Draft Specification for the AOS Frame Header Error Control Field

**Proposed update to 732.0-B-4
AOS Space Data Link Protocol**

Kenneth Andrews

Jet Propulsion Laboratory, California Institute of Technology

Figure 4-2: Transfer Frame Primary Header

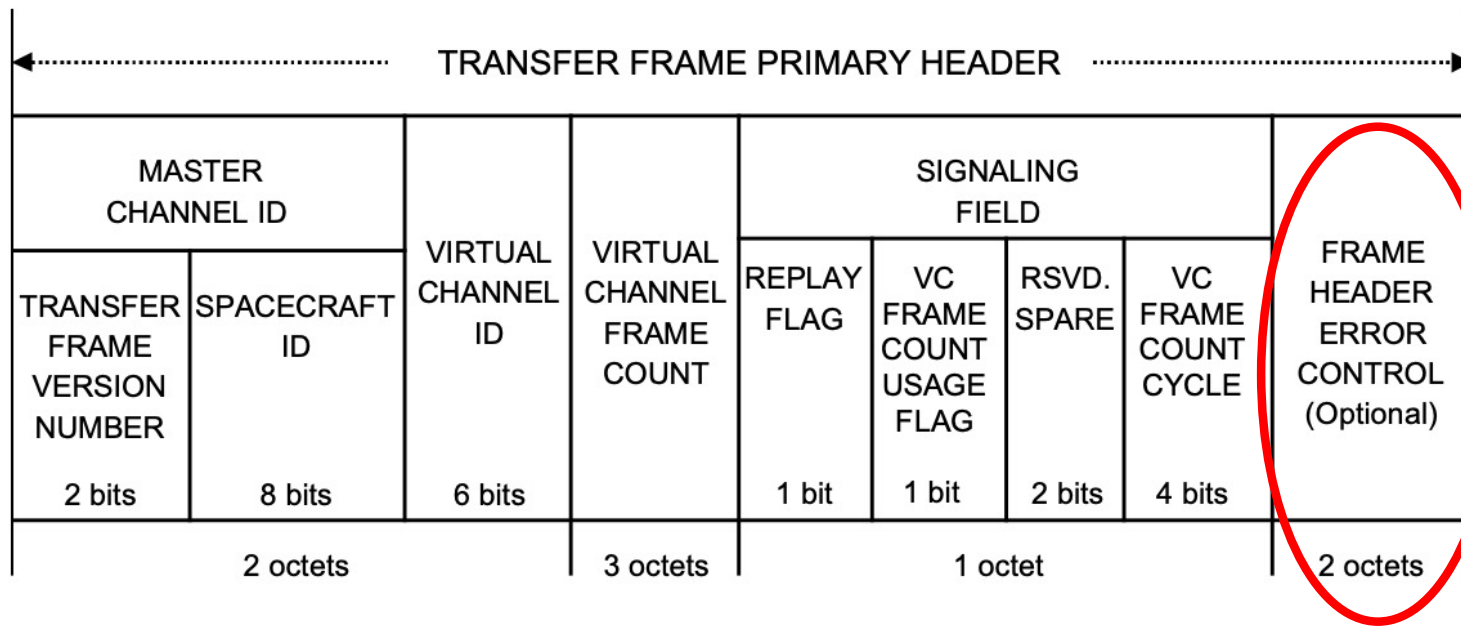
Correct the incomplete specification of the Frame Header Error Control field of the Transfer Frame Primary Header. Corrections should be consistent with existing implementations if possible.

The current specification is incomplete because it does not specify

- where the “virtual fill” is to be inserted
- what values should be used for that virtual fill

f) Five symbols of virtual fill shall be used to logically complete the Reed-Solomon codeword. This virtual fill shall:

- i. consist of all zeros;
- ii. not be transmitted;
- iii. be inserted only at the beginning of the codeword.

g) The selected code is a systematic code.
